[Docket No. FAA–2016–9418; Product Identifier 2016–NE–23–AD; Amendment 39–19167; AD 2018–02–14]

Airworthiness Directives; Honeywell International Inc. Turboprop and Turboshift Engines

ACTION: Final rule.

Figure 1 to Paragraph (h) of this AD. Combustion Chamber Case Assembly Without the One-Piece Bleed Pad with P3 Boss

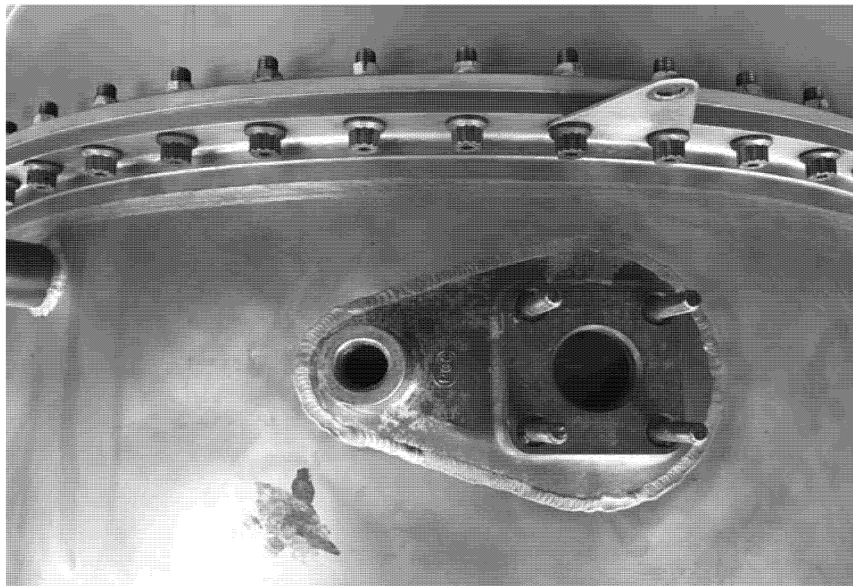
TPE331 model engines modified by STC SE383CH may be defined as the “Super 1” and “Super 2” for the compressor modification of the TPE331–1 and the TPE331–2, –2U, and –2UA engines, respectively. Figures 1 and 2 to paragraph (h) of this AD illustrate the appearance of combustion chamber case assembly, P/N

893973-5, without and with, respectively, the one-piece bleed pad with the P3 boss.

(i) Installation Prohibition

After the effective date of this AD, do not install a combustion chamber case assembly,

P/N 869728-1, 869728-3, or 893973-5, in TPE331-3U, -3UW, -5, -5A, -5AB, -5B, -6, and -6A engines or in TPE331-1, -2, and -2UA engines modified by National Flight

Services, Inc., STC SE383CH, unless the combustion chamber case assembly has a one-piece bleed pad with P3 boss.
